CITY OF MERCED

- B.1. [16-087](#) **SUBJECT: Joint Planning Commission/City Council Study Session on the Draft Zoning Ordinance**

DATE: February 4, 2016
TO: City Council and Planning Commission
FROM: Kim Espinosa, Planning Manager
SUBJECT: Final Recommendations from Merced Zoning Ordinance Update Focus Group regarding Specific Items from the Planning Commission/City Council Study Session on December 7, 2015

Reference : Comments on Revised and Reorganized Zoning Code

Figure 20.22-9 Side Court Apartments Example

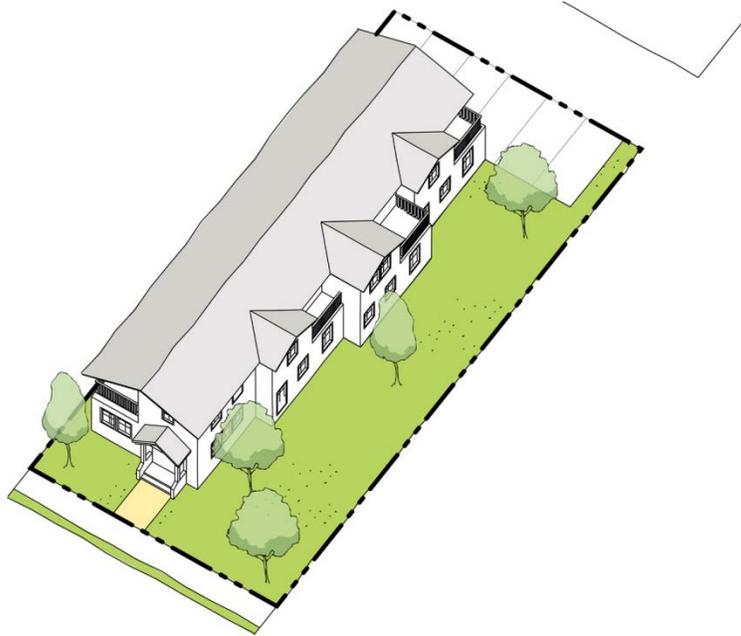
4 Page 84 h Side Court Apartments. Add sections (3) Pedestrian Access; (4) Central Courtyard; and (5) Frontage found on page 86 describing standards for Courtyard Apartments to provide residents good access to outdoor common areas.

- 4) *Side Court Apartments:* The Focus Group recommended that the following additional subsections be added: “4a) The side courtyard shall be a shared space accessible to all building residents. 4b) Pathways shall be provided from each unit to the side courtyard and from the side courtyard to a public sidewalk adjacent to the site.”

FIGURE 20.38-2 PARKING LOT LANDSCAPING STANDARDS

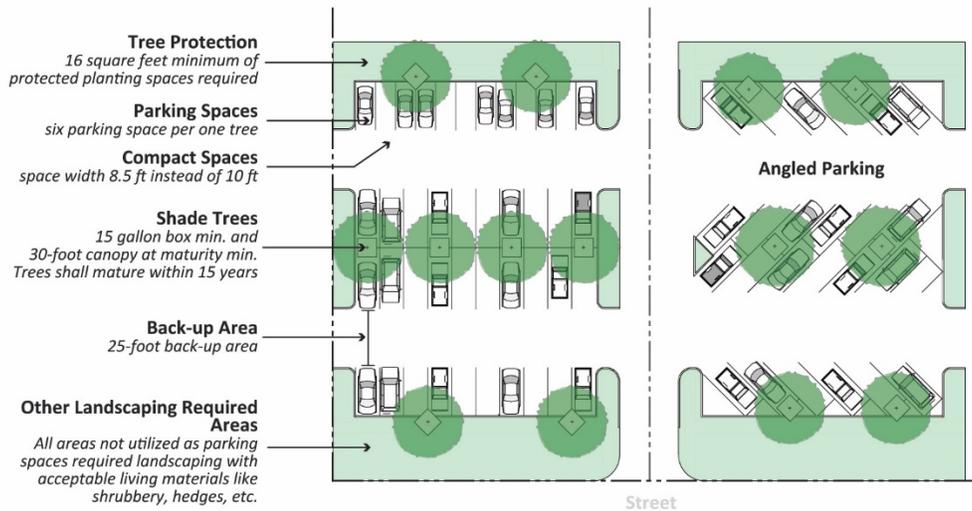
6 Page 132 Parking lot do standards not provide uniform, predictable design guidelines for incorporating solar panel "carports" which conflict with landscape requirements. There are no clear standards in the solar panel section of the ordinance on page 160 either regarding parking lot landscaping. We need staff to develop alternate draft standards to consider.

- (5) The above standards may be modified with a Minor Use Permit if alternative shade structures are provided. **[Proposal is to add standards for shade structures and solar carports instead of leaving up to staff to address with Minor Use Permits]**
